# 45 McLaren St

## North Sydney

Response to Council RFI

February 2024

Pictured  
Ground Level

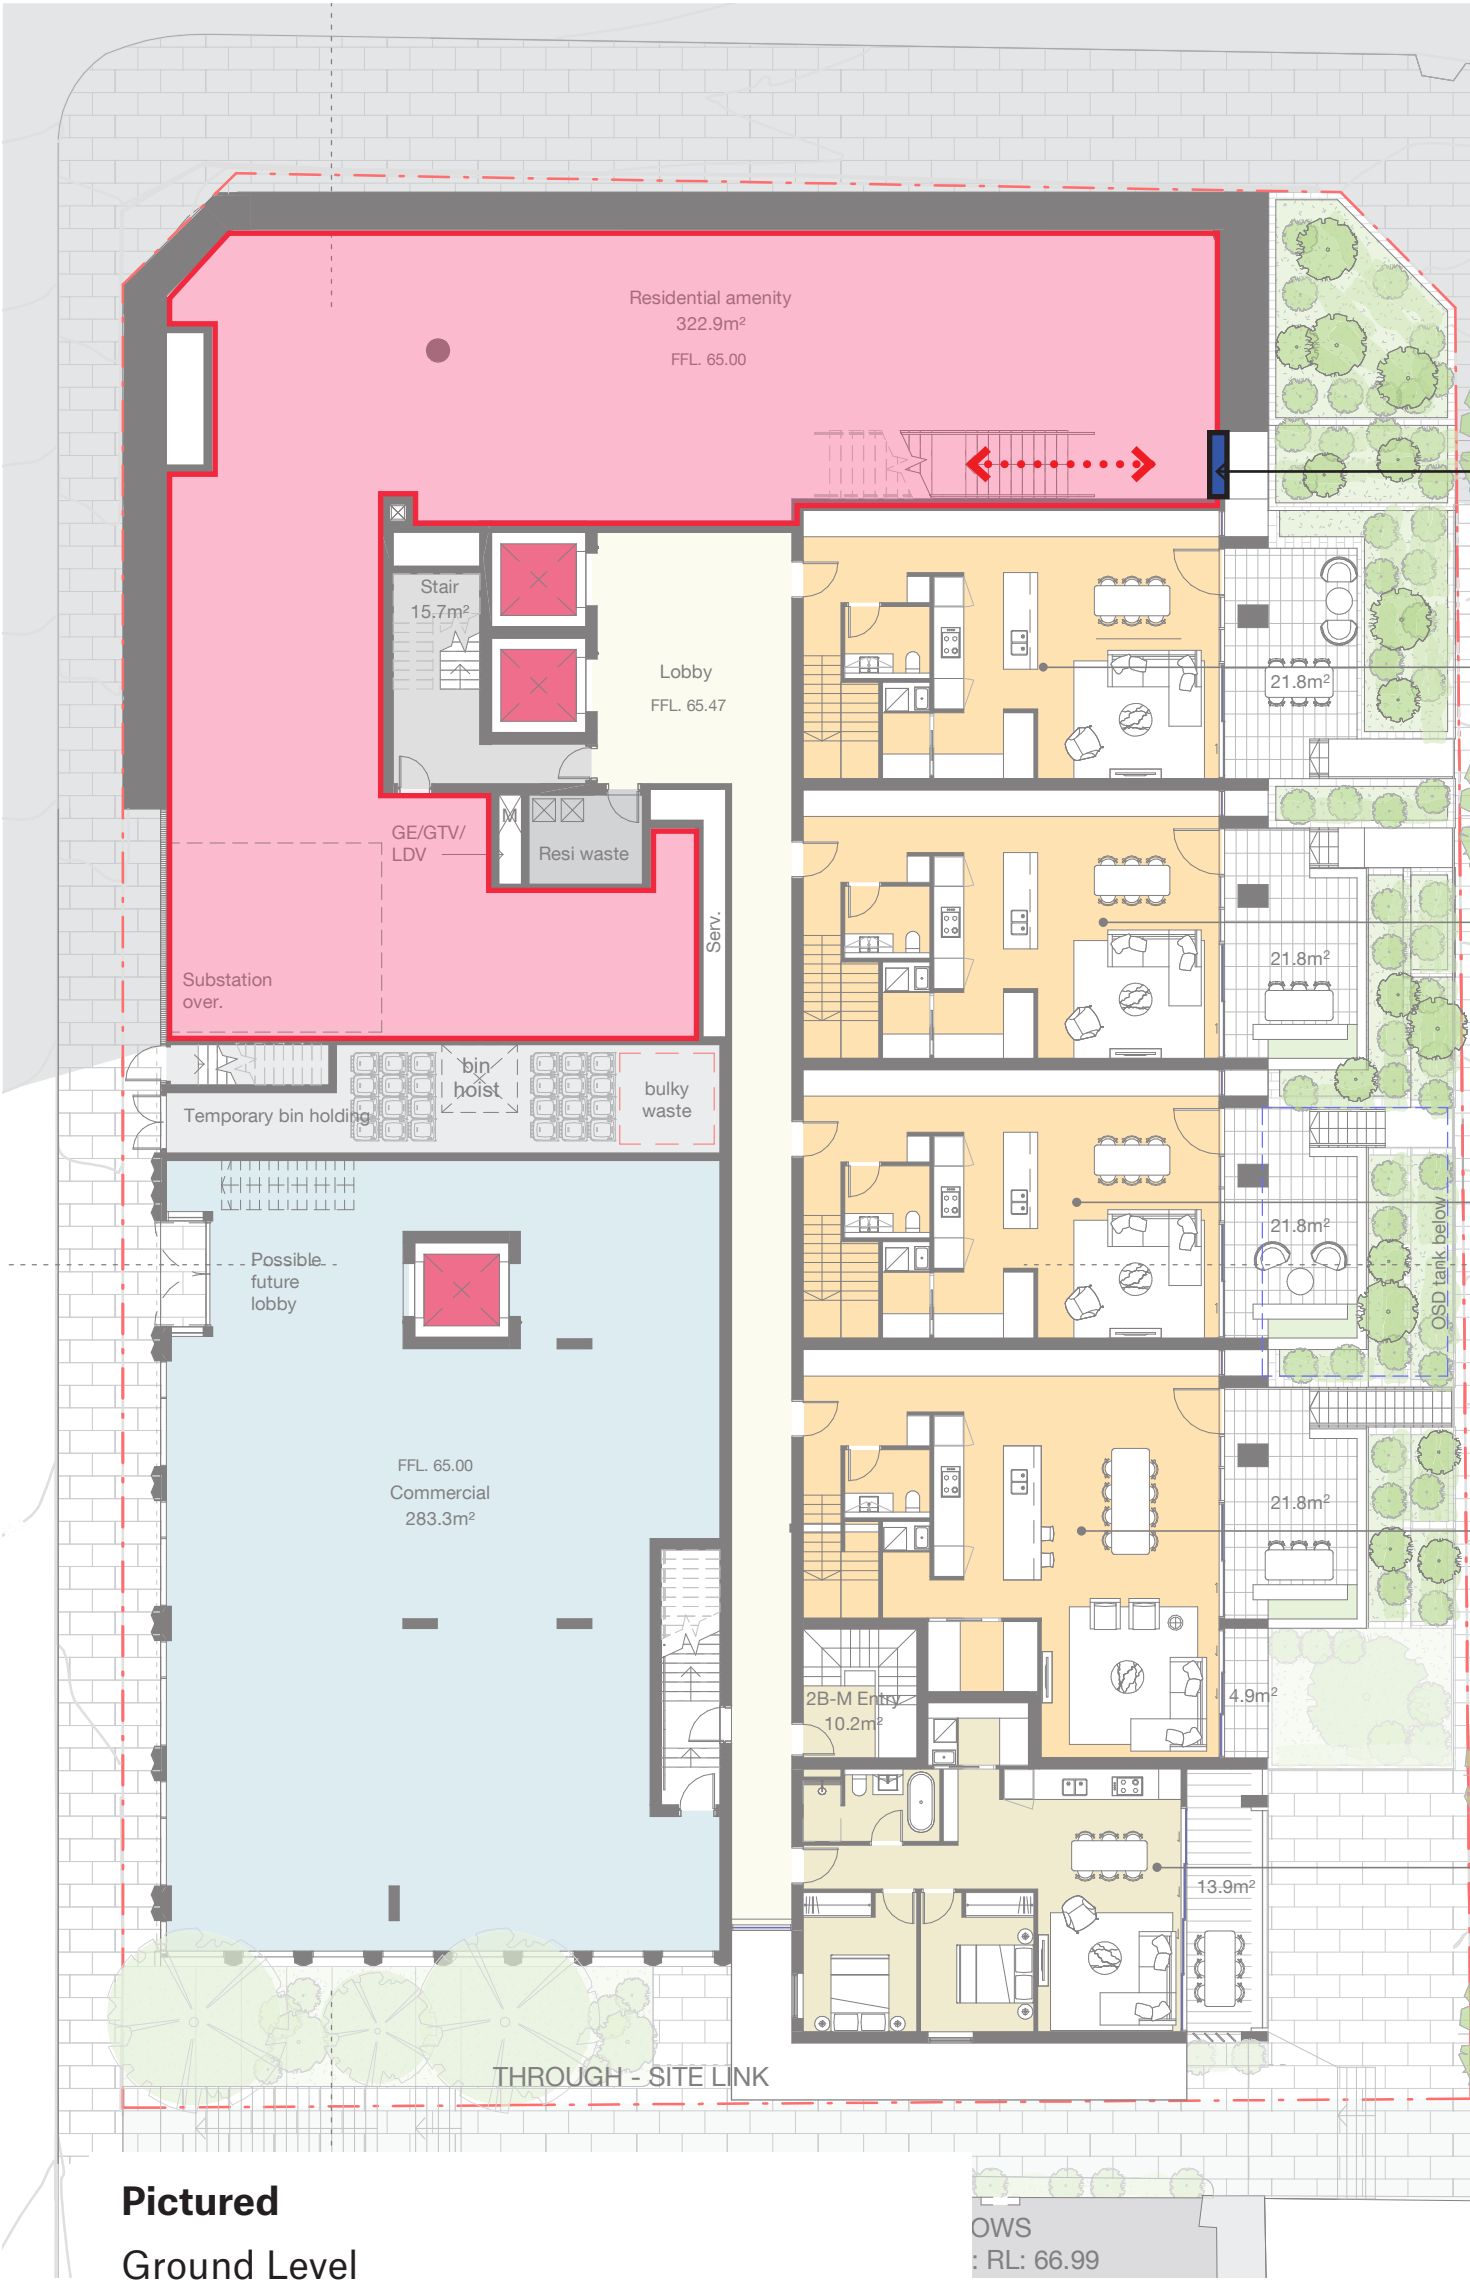
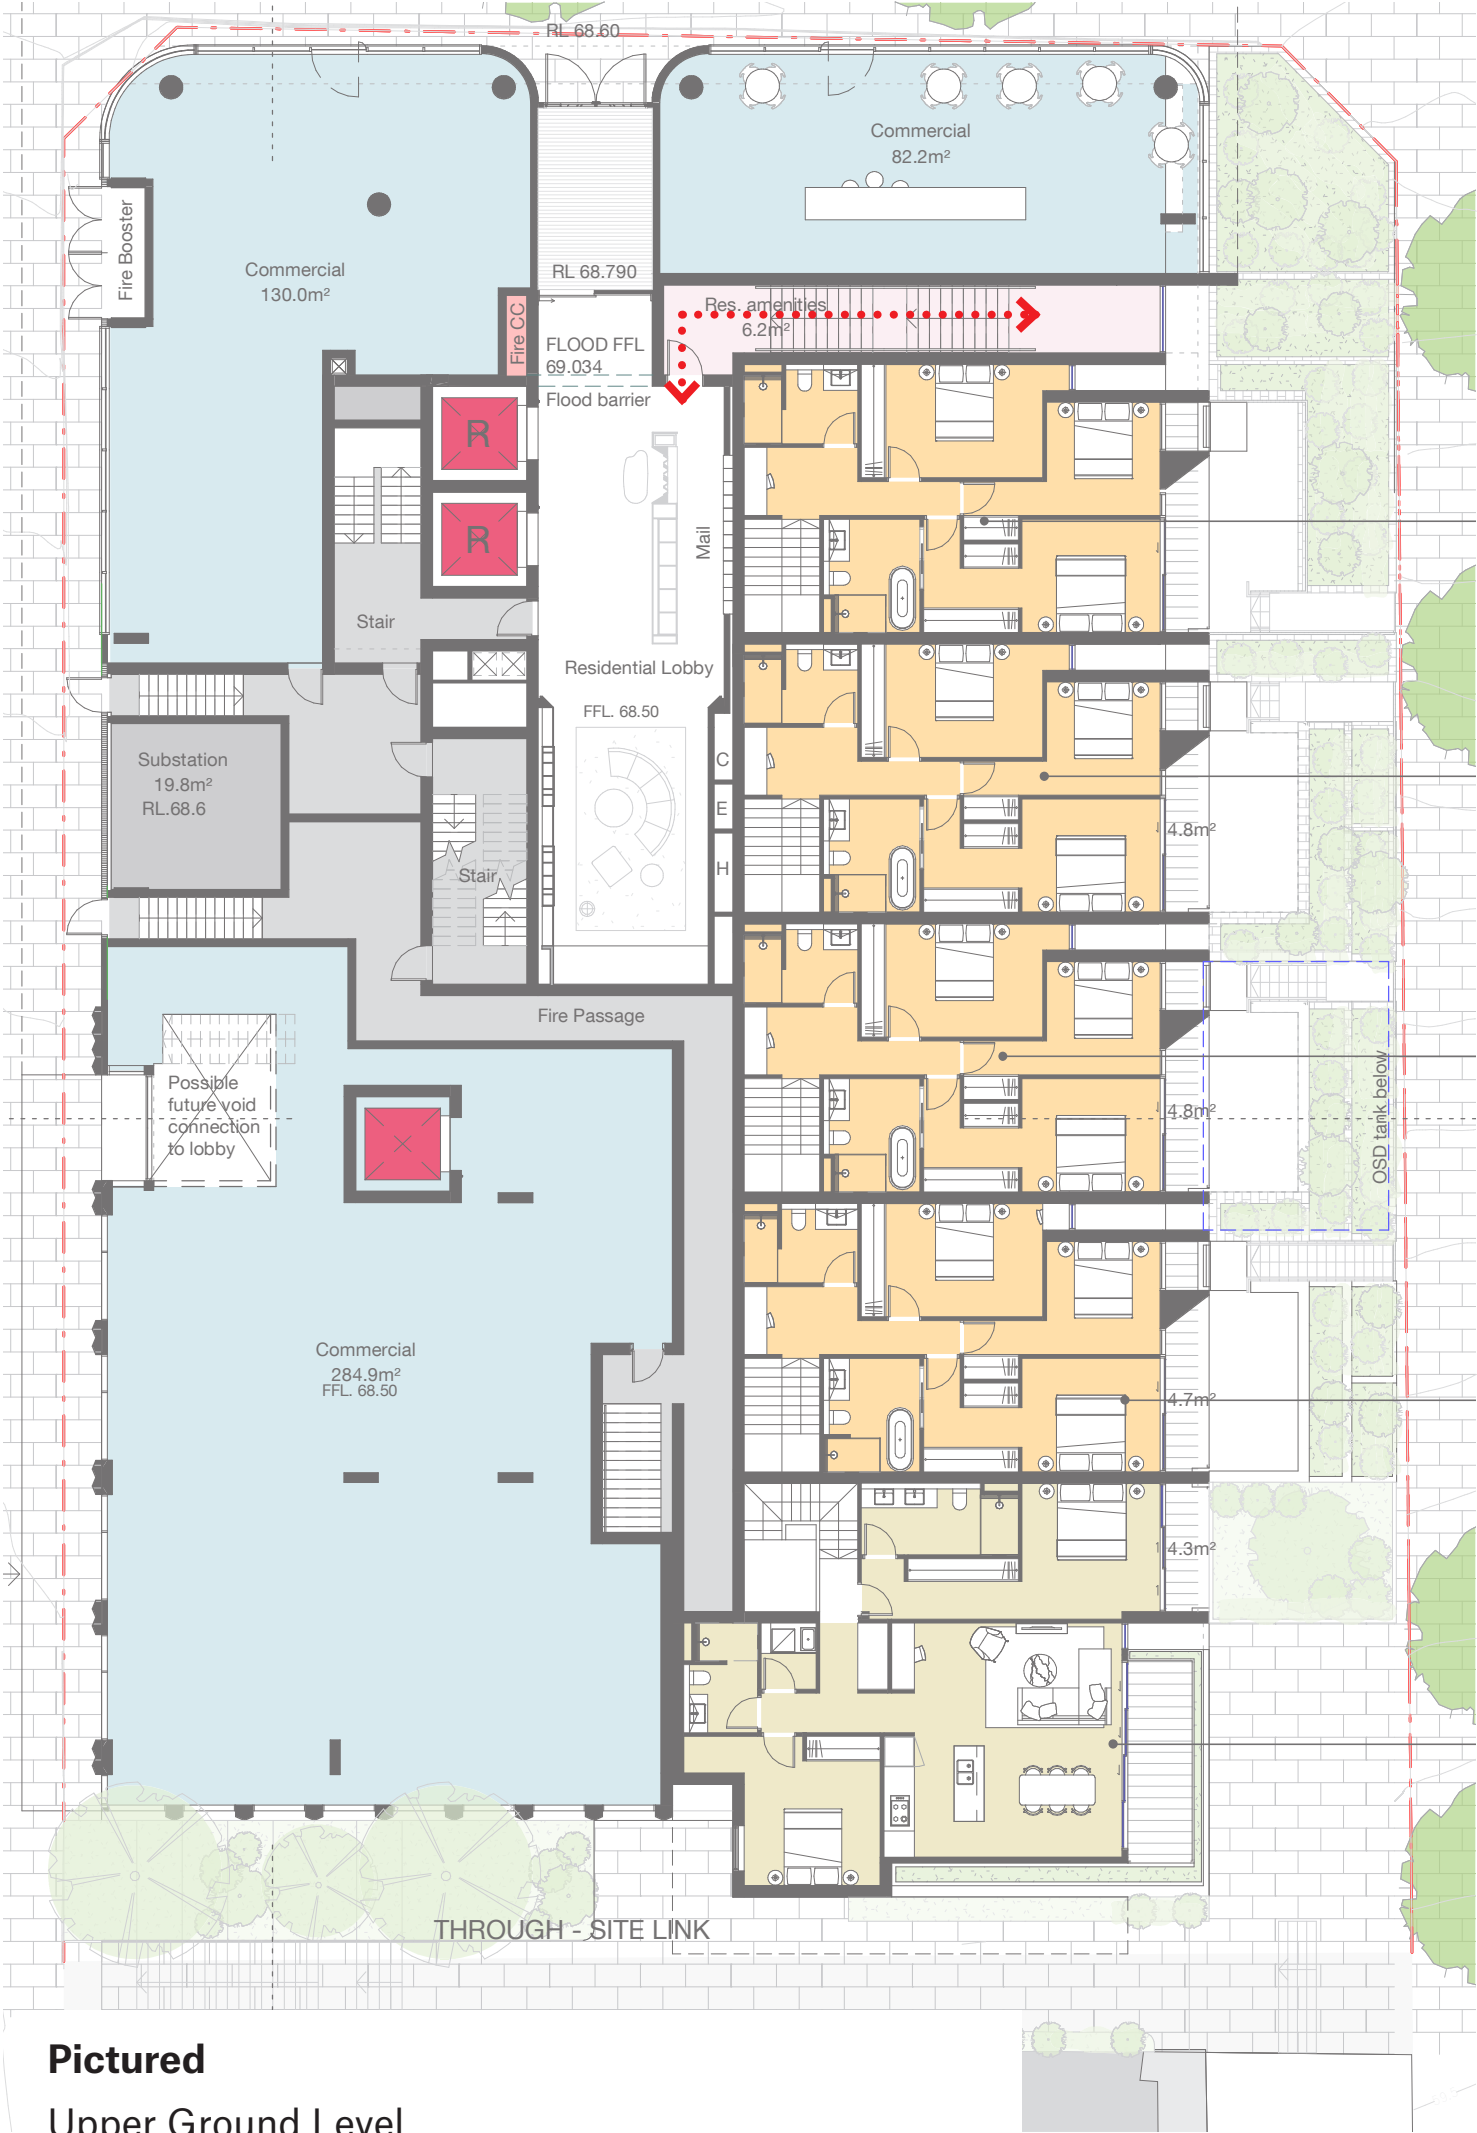
*The **underground communal space** is **not considered appropriate**, it should be located above ground.*

The resident amenity spaces proposed in the basement levels have been relocated to Ground Floor. A new stair and void integrates this amenity space with the main residential lobby and introduces natural light and outlook to the amenity spaces.

Window with  
slab opening to  
allow natural light  
penetration into  
residential amenity
